Item Name: Crosstube Turning Detail

DART AEROSPACE LTD	Work Order: 76825
Description: Crosstube Assembly (412 High Aft)	Part Number: D412-664-243
Inspection Dwg: D412-664-243 Rev: E	Page 1 of 1

DRAWING NO. D412-664-243	TITLE CROSSTUBE ASSEMBLY (412 HI AFT)	REV. E	DART AEROSPACE LTD ENGINEERING ORDER		D.E.O. NO. D412-664-243-E-1	SHEET NO. SHEET 1 OF 2	SCALE NTS
DRAWN	CHECKED	MFG. APPR.	APPROVED		DE APPR.		
DATE 11.03.31	DATE 11/03.31	DATE 11.03.31	DATE 11/03.31		DATE 11.03.31

DRAWING NO. D412-664-243	TITLE CROSSTUBE ASS'Y (412 HI AFT)	REV. E	DART AEROSPACE LTD ENGINEERING ORDER		D.E.O. NO. D412-664-243-E-2	SHEET NO. SHEET 1 OF 1	SCALE NTS
DRAWN qp	CHECKED ASS	MFG. APPR. E	APPROVED MP		DE APPR. H		
DATE 11.09.07	DATE 11.09.19	DATE 11.09.19	DATE 11.09.19		DATE 11.09.19

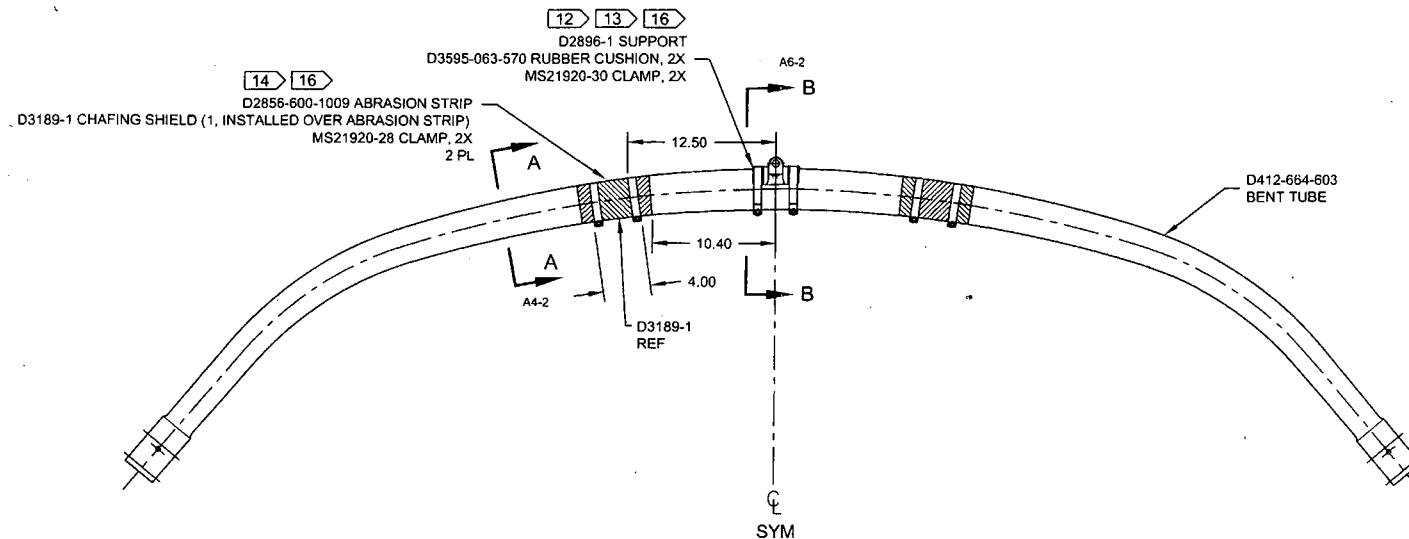
REMOVED ABRASION STRIP IN FAVOR OF A THIN LAYER OF PROSEAL 890.

NOTES 2 AND 14, SHEET 1 ARE AMENDED AS FOLLOWS:

- 2) FINISH: CHEMICAL CONVERSION COAT PER DART QSI 005 4.1
PRIME INSIDE AND OUTSIDE PER DART QSI 005 4.2
MASK UNDERSIDE OF CROSSTUBE AS SHOWN (HATCHED AREA)
PAINT OUTSIDE PER DART QSI 005 4.2
AFTER PAINTING, APPLY CLEAR COAT ON HATCHED AREA
- 14) APPLY A THIN COAT OF PROSEAL 890 ON INSIDE CONCAVE SURFACE OF D3189-1
CHAFING SHIELD AND LET CURE PER MANUFACTURER'S INSTRUCTIONS. INSTALL
PROSEAL D3189-1 CHAFING SHIELD ONTO CROSSTUBE BY APPLYING A THIN COAT OF
PROSEAL 890 ONTO CROSSTUBE. BE SURE TO ELIMINATE ANY AIR GAPS.

- 2) FINISH: CHEMICAL CONVERSION COAT PER DART QSI 005 4.1
PRIME INSIDE AND OUTSIDE PER DART QSI 005 4.2
PAINT OUTSIDE PER DART QSI 005 4.2
- 14) INSTALL D2856-600-1009 ABRASION STRIPS WITH A 0.13 REF GAP ON BOTTOM SIDE OF
CROSSTUBE PER QSI 035.
